TECHNICAL NOTE			TN. 04
Revision	2	Date:	12th June 2025
Principal's Representative:	Andrew Allsopp-Smith		
Contractor:	Apex Water		
Contract:	Delmore Wastewater Treatment Plant		
Contract No.:	241104		
Subject:	Technical Note – Engagement Requests for Additional Information

Technical Note – Support of Delmore Consent Application

In support of the Delmore fast-track consent application, Apex Water has prepared this technical note in response to engagement feedback provided by stakeholders related to the development of private, on-site wastewater treatment and discharge infrastructure for the Delmore land development project.

Figure 1 – Omaha Wastewater treatment plant wastewater discharge via surface mounted drip irrigation through both bushy and wooded areas.

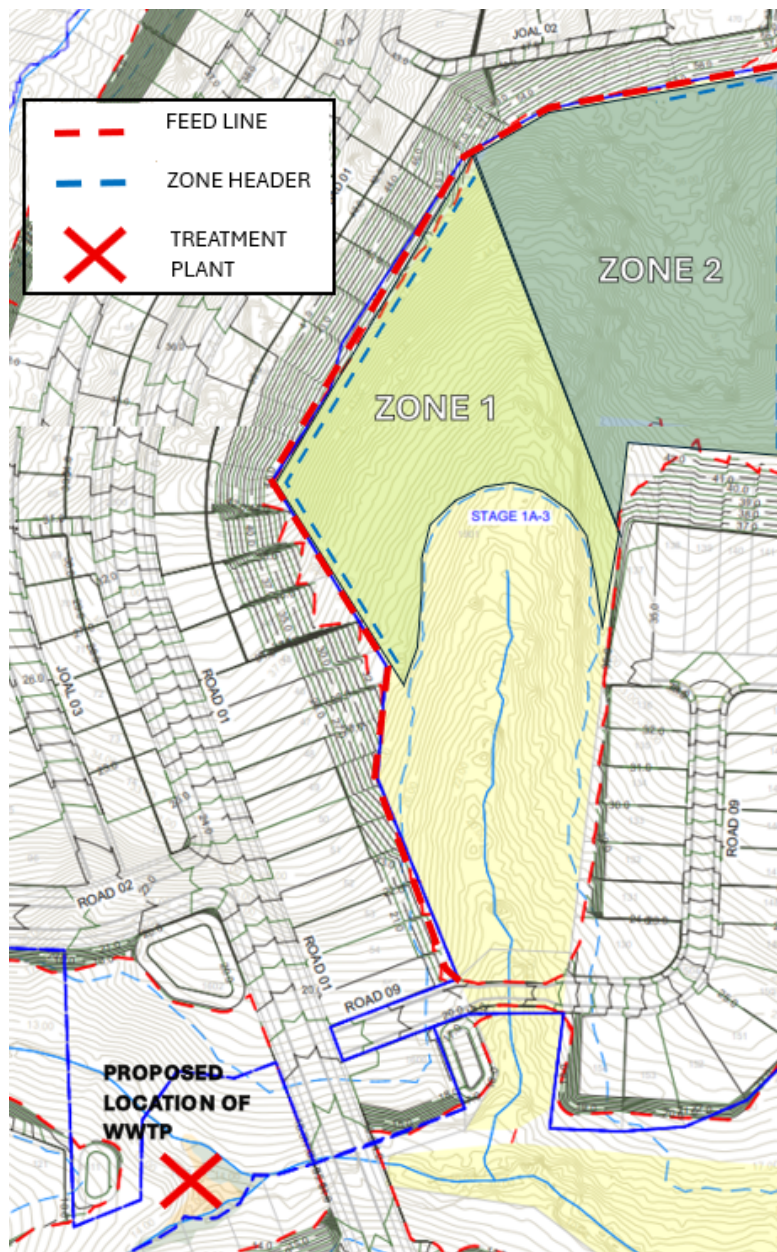
Minimal information provided regarding irrigation field.

Watercare Services Limited currently operate facilities which include discharges of treated wastewater via surface mounted pressure compensated driplines into wooded or densely planted bushy lots, such as those proposed by the substantive fast-track application as lodged. One such example is the Omaha Wastewater Treatment Plant where wastewater is discharged into both wooded and densely planted bushy areas, as shown in Figure 1 below.

A limited indicative layout of the irrigation system is provided in Figure 2 below. This figure illustrates the two irrigation zones and potential header pipe configurations. The alignment of driplines will as best as possible follow along the contour lines of the field at appropriate spacings. The main supply line and distribution headers have been routed to avoid traversing the irrigation area itself. As a result, all work within the irrigation field will be confined to the surface installation of the dripline which can be installed by hand and pinned to the soil.
